## ADDENDUM NO. 1

**City of Mercer Island, Washington**  
**77<sup>th</sup> Ave SE & Sunset Hwy SE Intersection Improvements**  
**PROJECT NUMBER SP120**

DATE OF ADDENDUM ISSUE: June 23, 2022  
DATE OF BID OPENING: June 30, 2022

**TYPICAL SECTIONS**

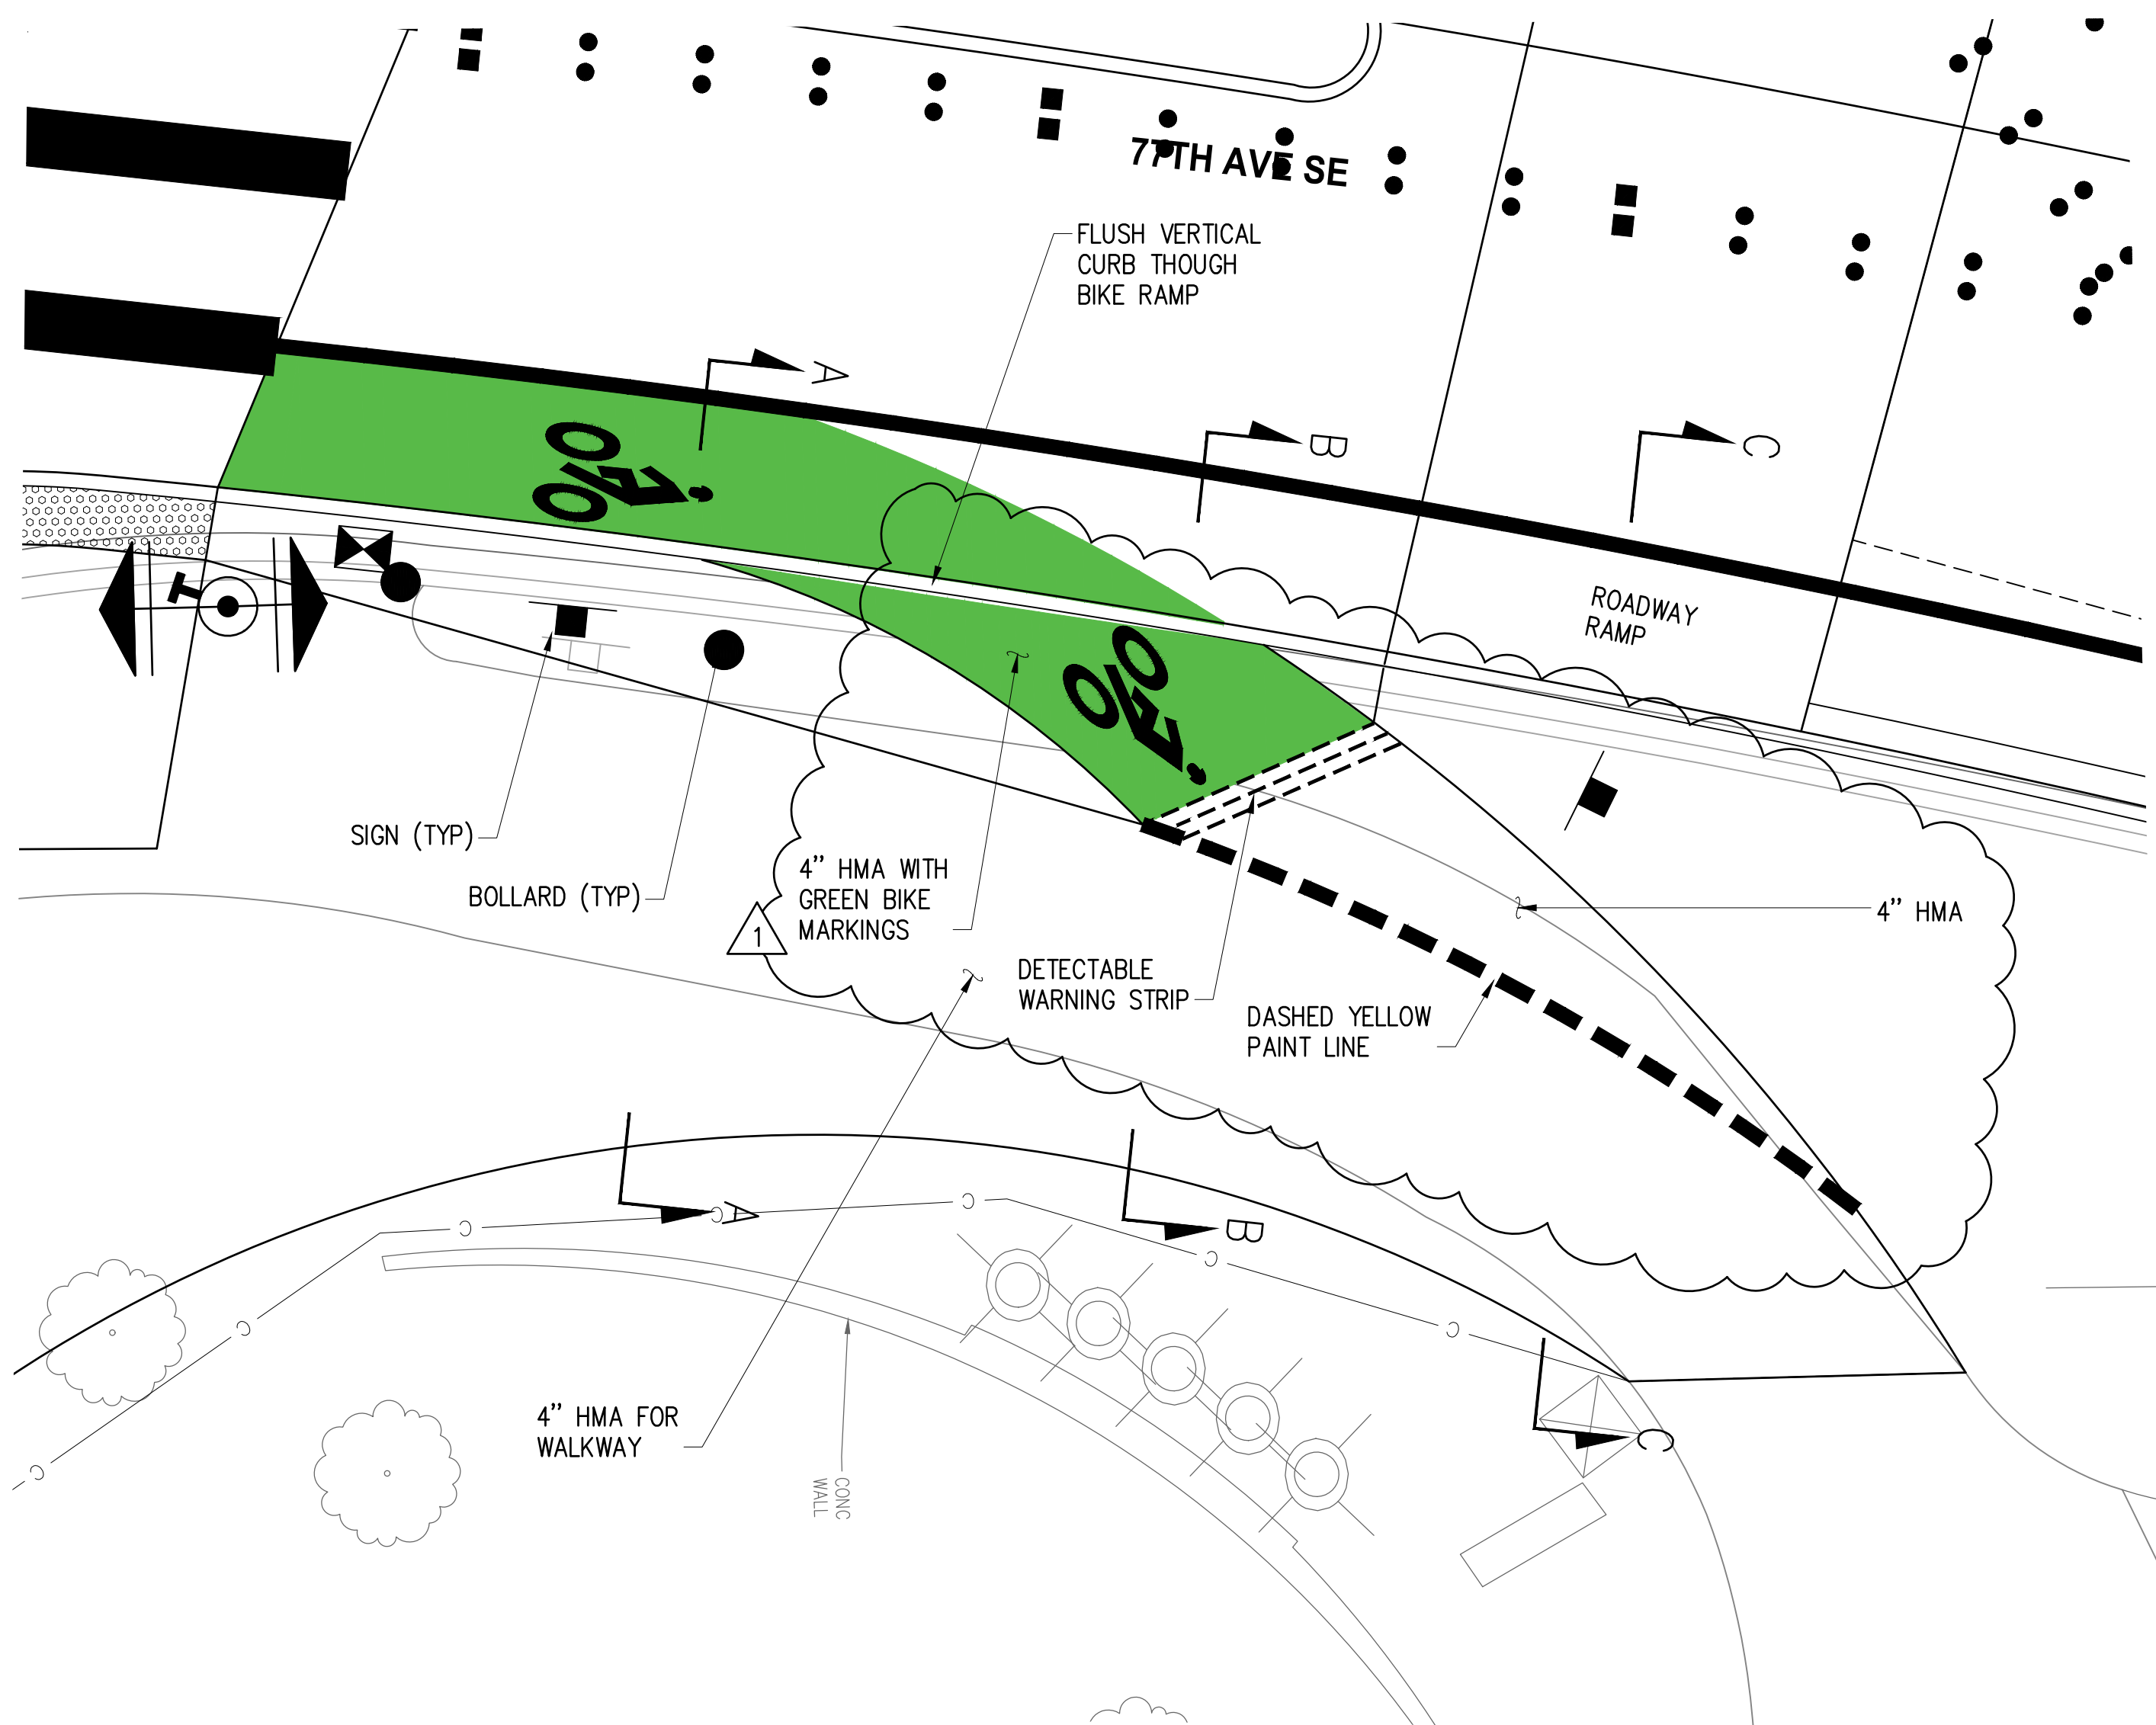
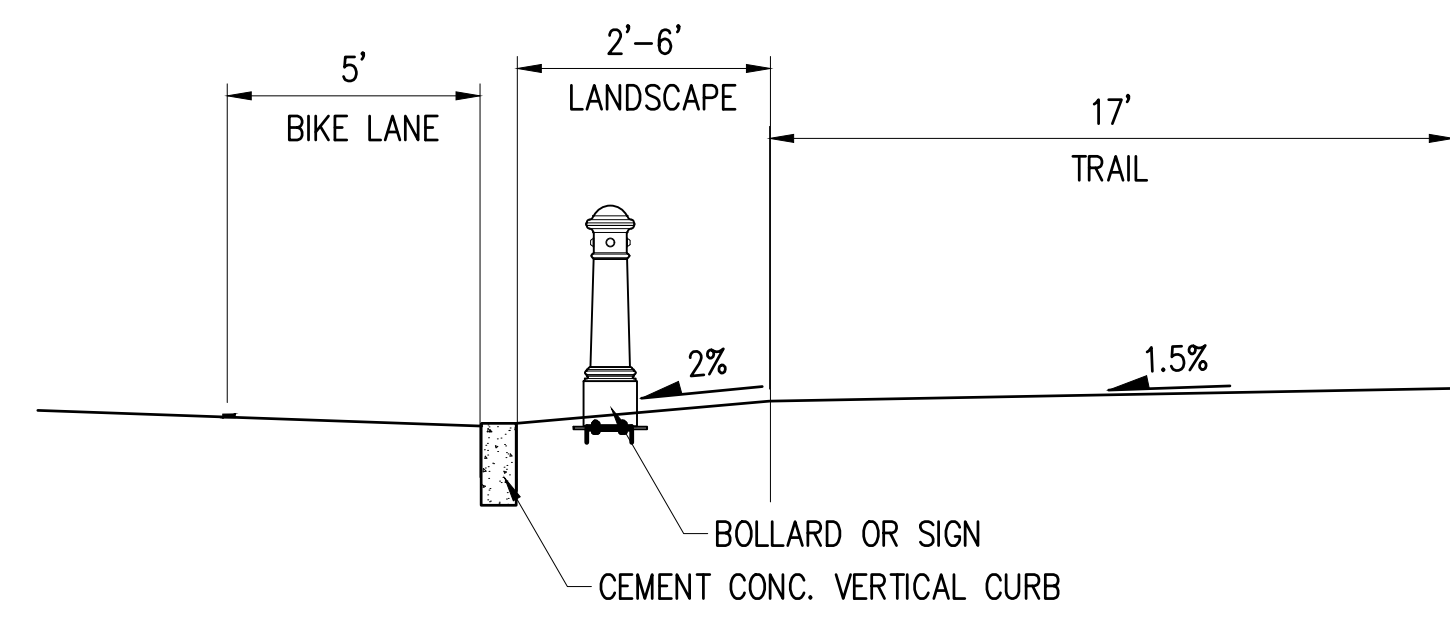
- Page 4: Lane Width Revision
- Page 18: Revision to the Bike Ramp Channelization and addition of detectable warning strip detail
- Page 23: Revision to the Channelization callout and lane widths
- Page 27: Revision to Phase Two and Three General Note 8.
- Page 29 & 30: Addition of note describing one-way flagging operation for Sunset Highway SE west leg.

NO.	DATE	BY	APPR.	REVISIONS
1	6/23/22	BMC	BMC	LANE WIDTH REVISIONS

<b>BIKE RAMP DETAIL</b>	
KPG PROJECT No. 21103	SHT 18 OF 30

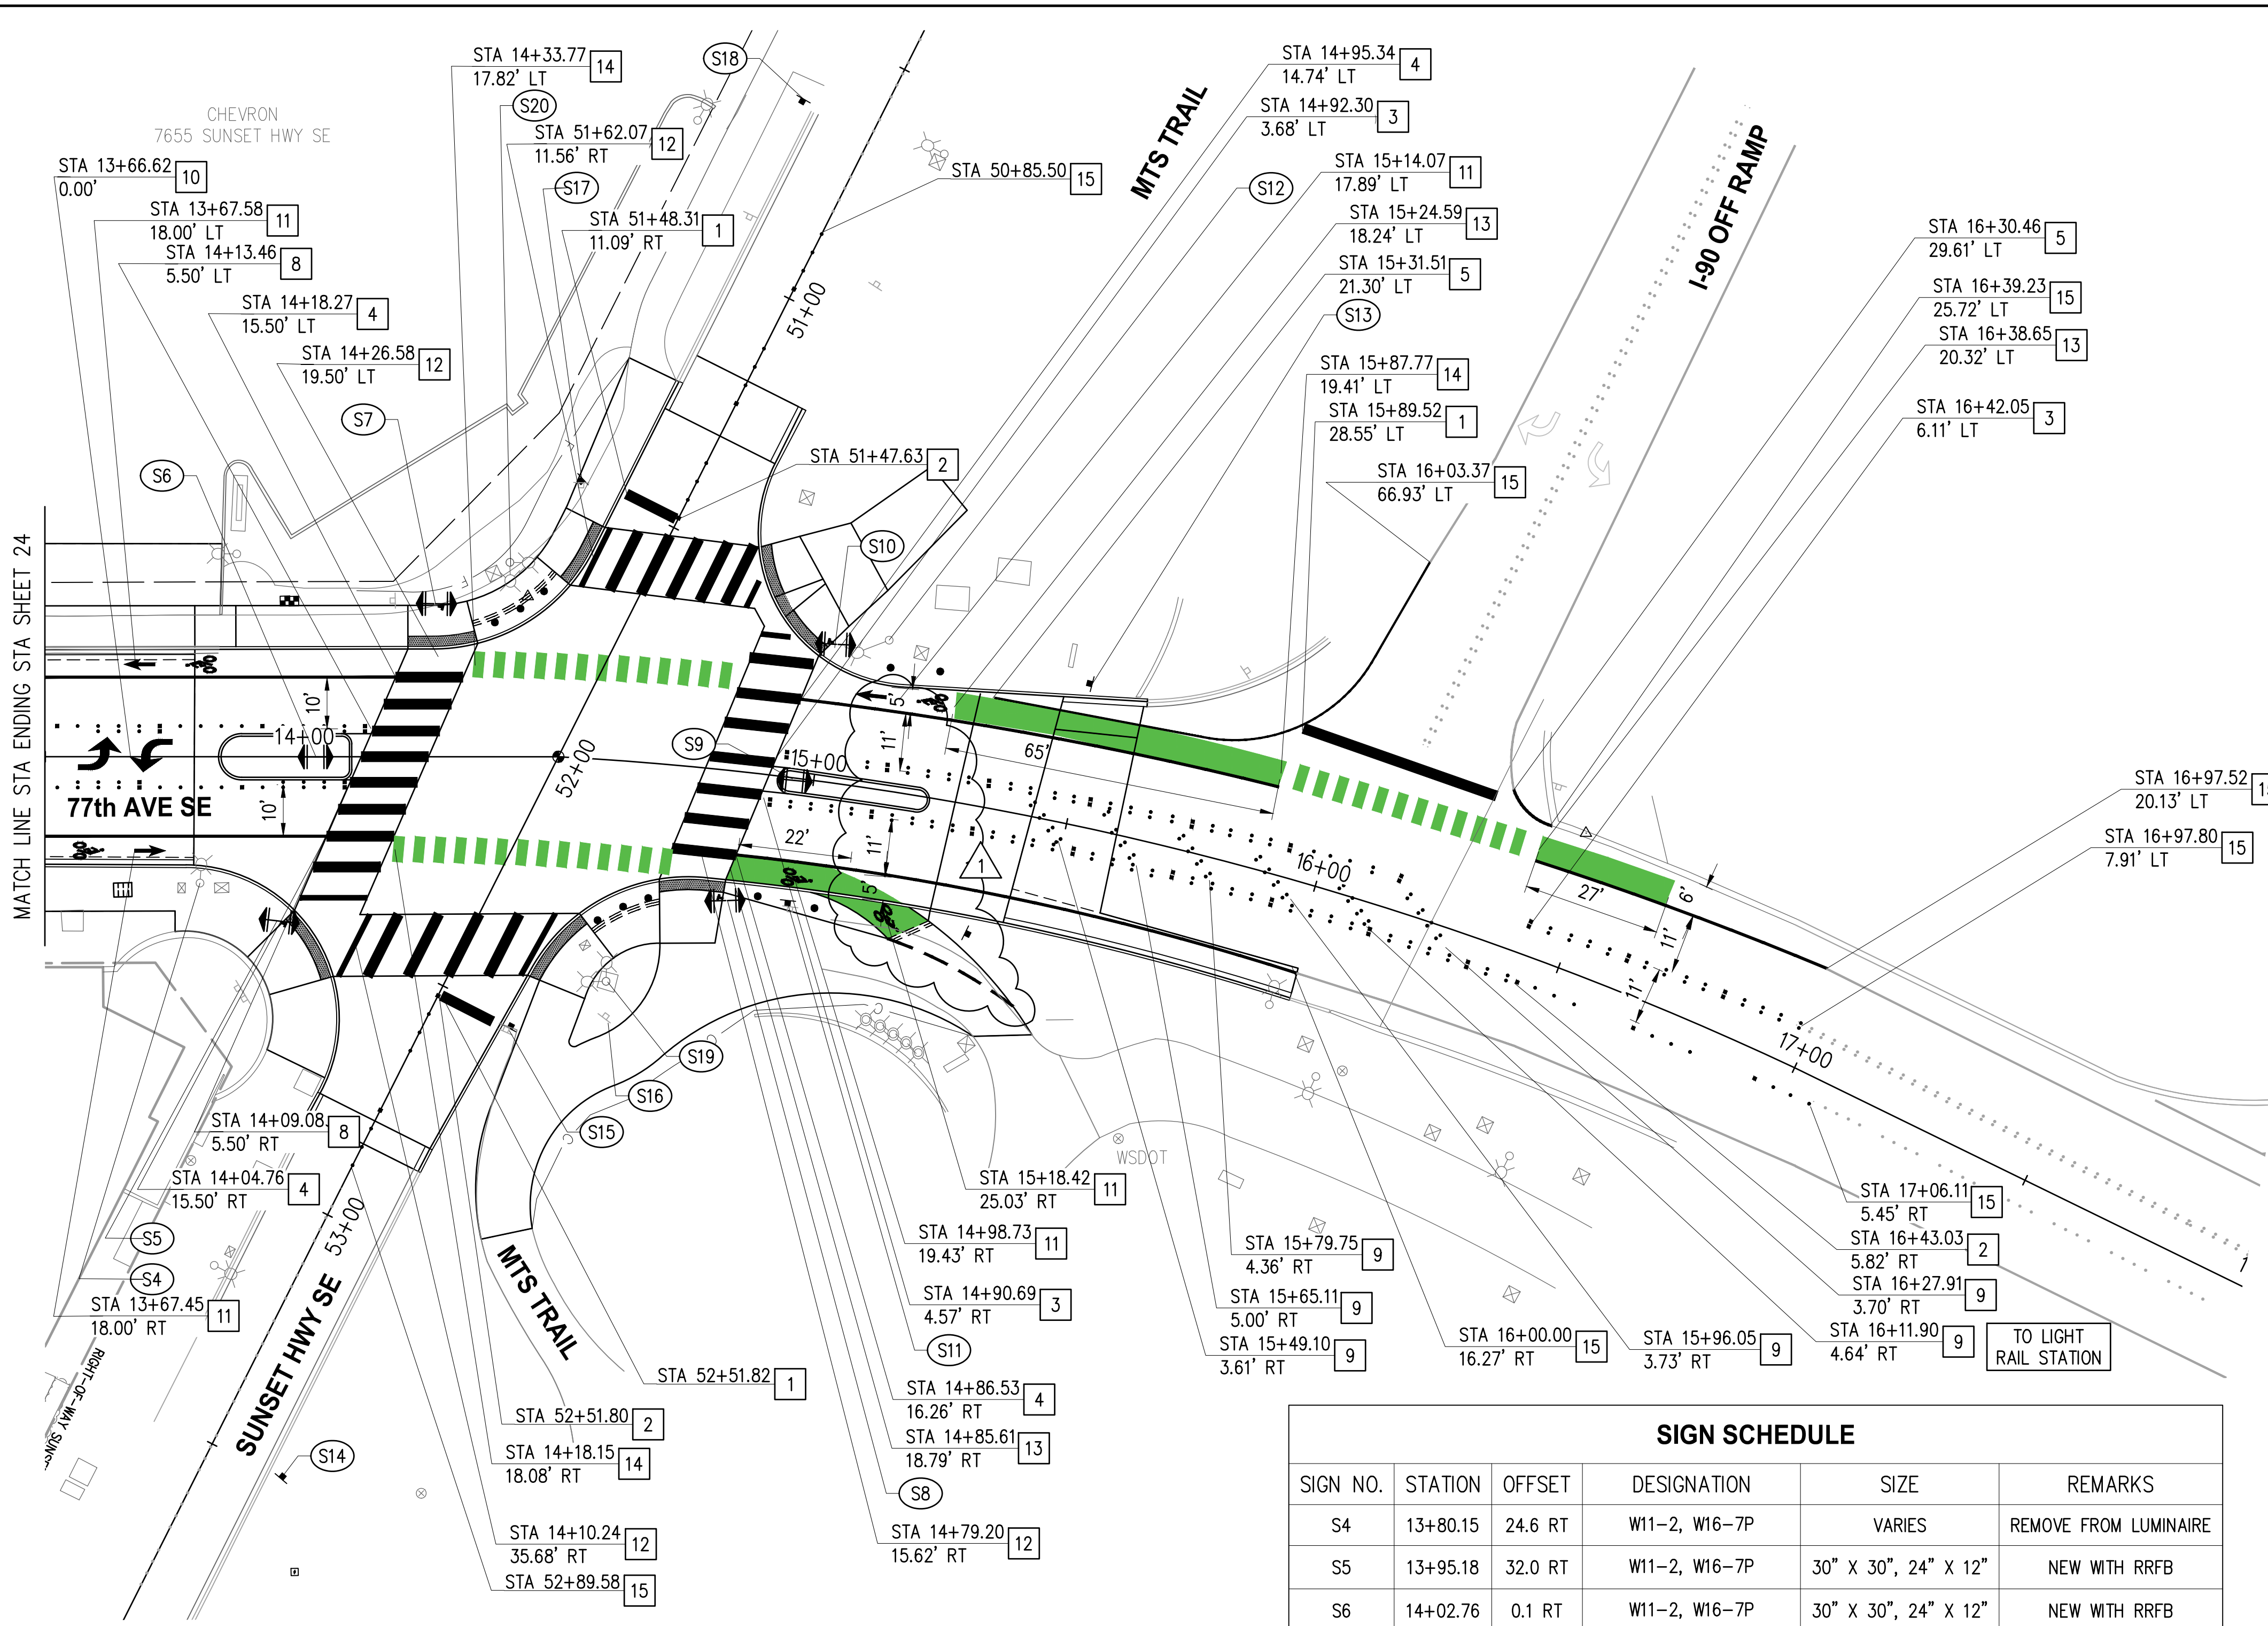
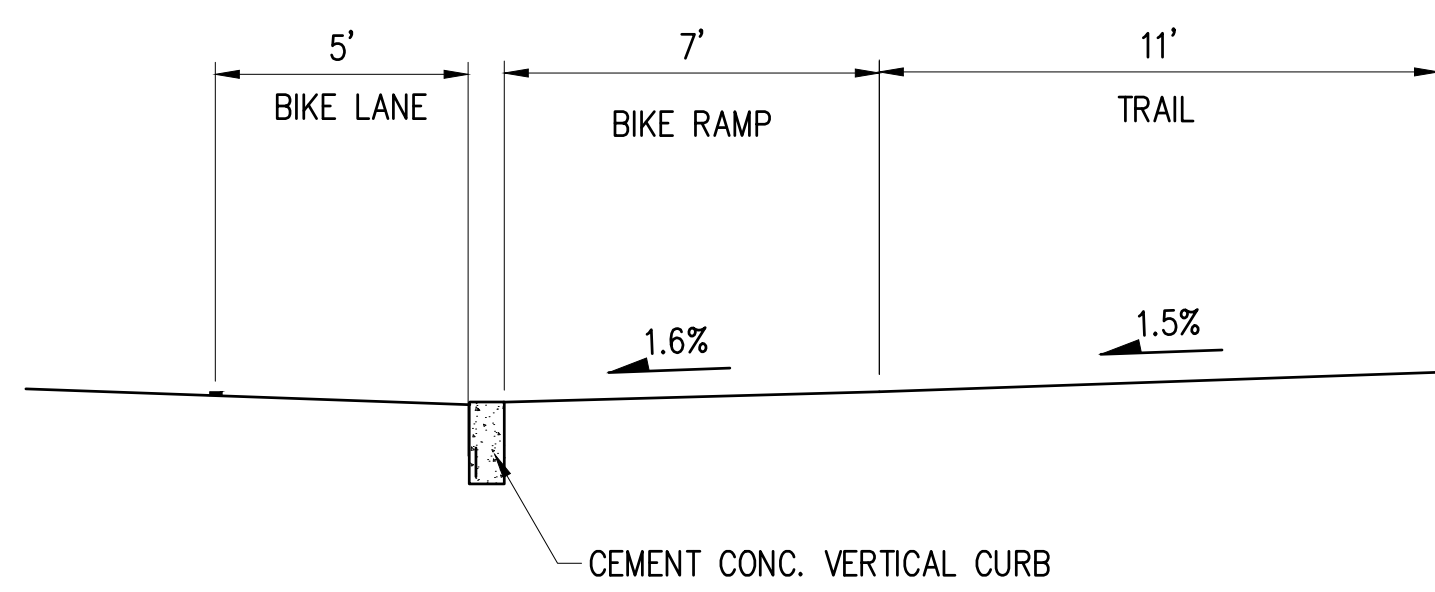
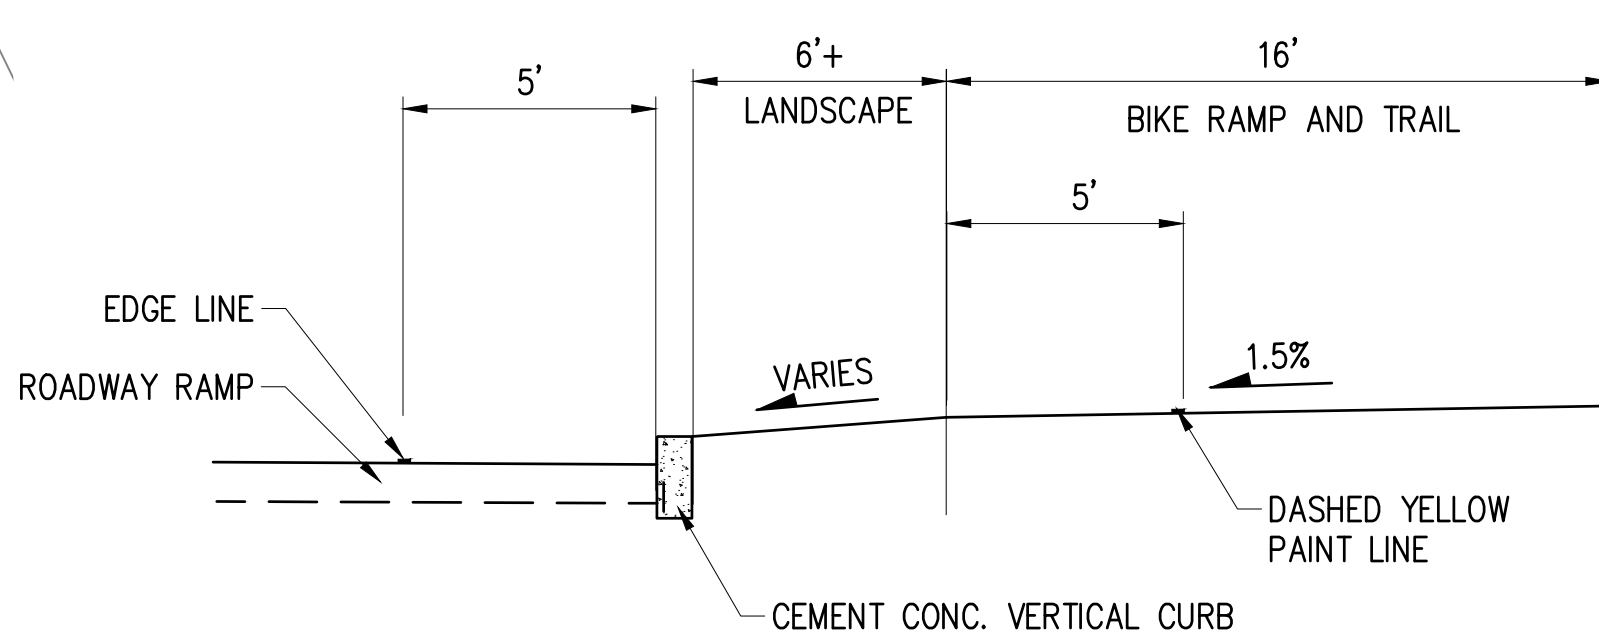
NO.	DATE	BY	APPR.	REVISIONS
1	6/23/22	BMC	BMC	BIKE RAMP CHAN
